FOSTER RIDGE INDUSTRIAL PARK
PRELIMINARY OVERALL AREA
DEVELOPMENT PLAN

INFORMATION SHEET FOR
PRELIMINARY OVERALL AREA DEVELOPMENT PLAN
(P.O.A.D.P.)

RE: Foster Ridge POADP
File #254

PRELIMINARY ENGINEERING REPORT
ON THE FEASIBILITY OF THE CITY WATER BOARD
PROVIDING WATER SERVICE TO THE
FOSTER ROAD 698 ACRE TRACT
IN SERVICE LEVEL 3

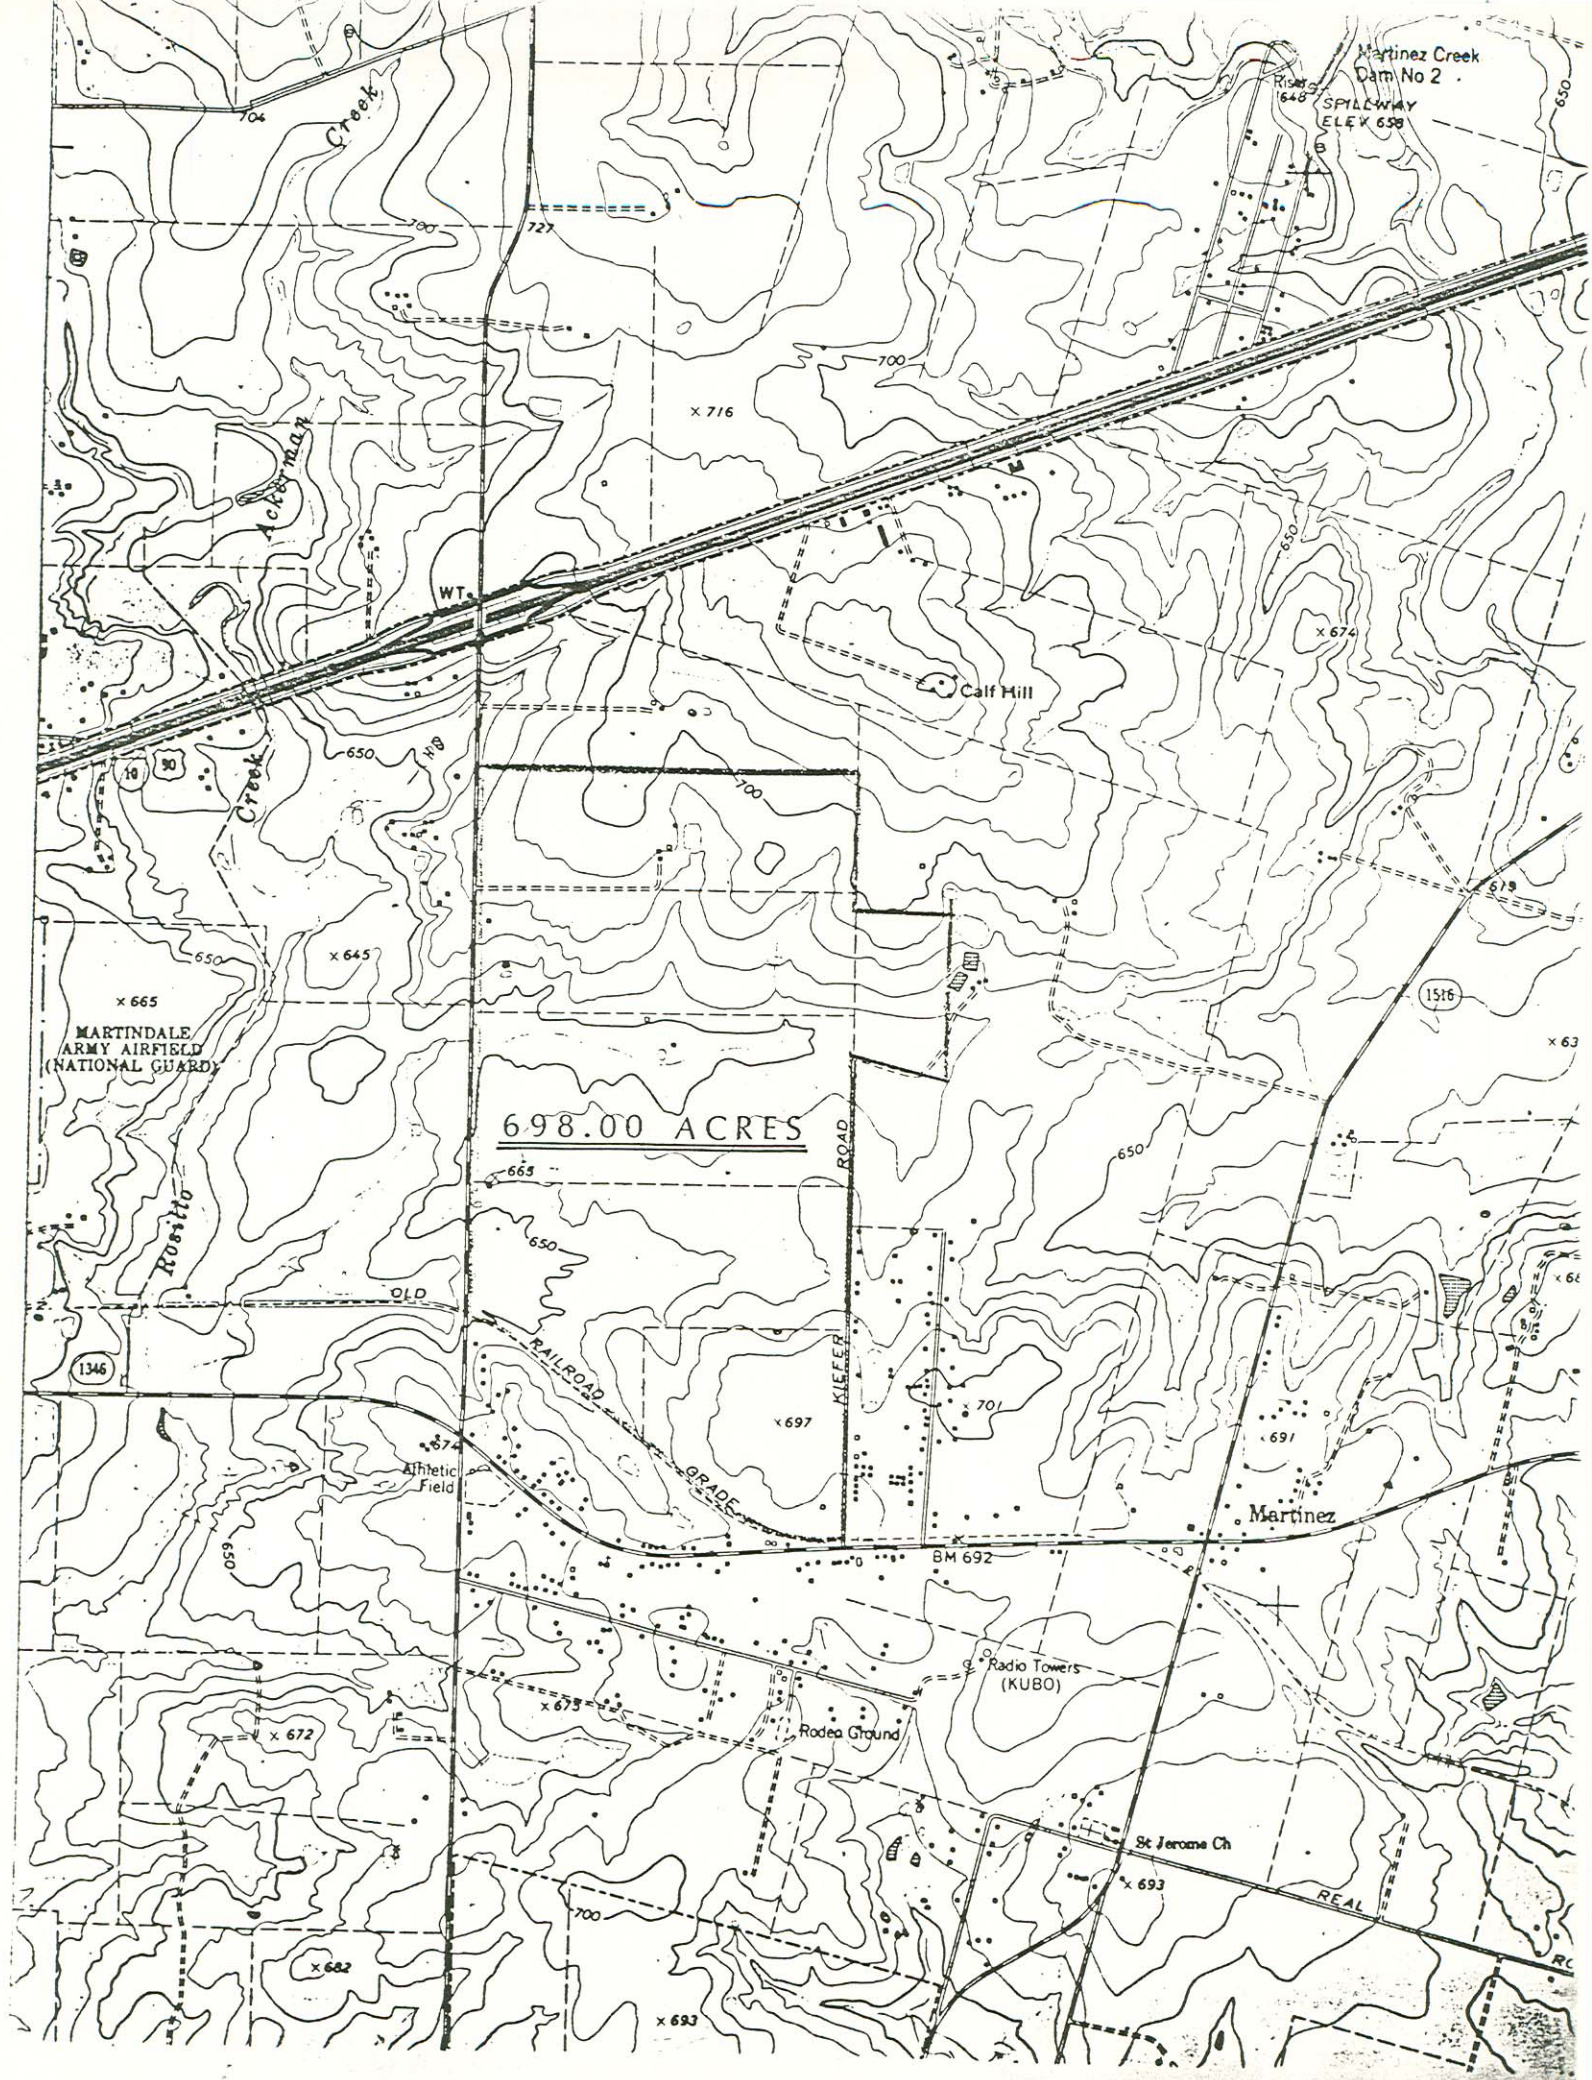
- II. The tract is located on Foster Road between I.H. 10 and St. Hedwig as shown on the attached sketch.
- III. The tract is proposed for mixed-use development consisting of residential and commercial uses. The ultimate demand on the City Water Board's system is anticipated to be equivalent to 2,792 dwelling units. Water supply to the area will be from Service Level 3. The excess system capacity of Service Level 3 can accommodate this requirement.

- IV. To provide water supply for domestic and fire protection service in accordance with the Board's Criteria a flow capacity of 5,292 gpm is required. There is an existing 20-inch main on St. Hedwig at Foster Road and an existing 12-inch main on I.H. 10 approximately 5,300 feet west of Foster Road with adequate capacity to supply the required water demand. A 16-inch approach main on Foster Road from St. Hedwig to the tract, approximately 1,400 feet, and a 12-inch approach main on I.H. 10 and Foster Road from the existing 12-inch main to the tract, approximately 6,500 feet, will be required at the developer's initial expense. The 16-inch and 12-inch approach mains are estimated to cost \$42,000 and \$162,500 respectively. These dual approach mains will also satisfy the Board's Criteria for multiple connections. The developer will also be required to install the necessary on-site mains and facilities in accordance with the Board's Criteria.

- V. In accordance with the Board's Master Plan it is recommended that the required 12-inch approach main along Foster Road be oversized to 16 inches. The estimated cost of installing approximately 1,200 feet of 16-inch oversized approach main is \$36,000. The City Water Board's and developer's proportionate share of the cost is estimated to be \$12,000 and \$24,000 respectively. The recommended 16-inch oversized approach main is subject to the approval of the San Antonio City Council.

It is recommended that Pape-Dawson Engineers be informed that the City Water Board can provide water service to the Foster Road 698 acre tract on a developer customer basis as provided for in the Board's Regulations. Such a water service commitment will require the applicant to provide the initial funding for the required 16-inch and 12-inch approach mains as well as the total cost of local benefit facilities. It is also recommended that the required 12-inch approach main along Foster Road be oversized to 16 inches subject to the approval of the San Antonio City Council. It is further recommended that this commitment for service be honored for four months, and if not exercised during that period, the application must be resubmitted.
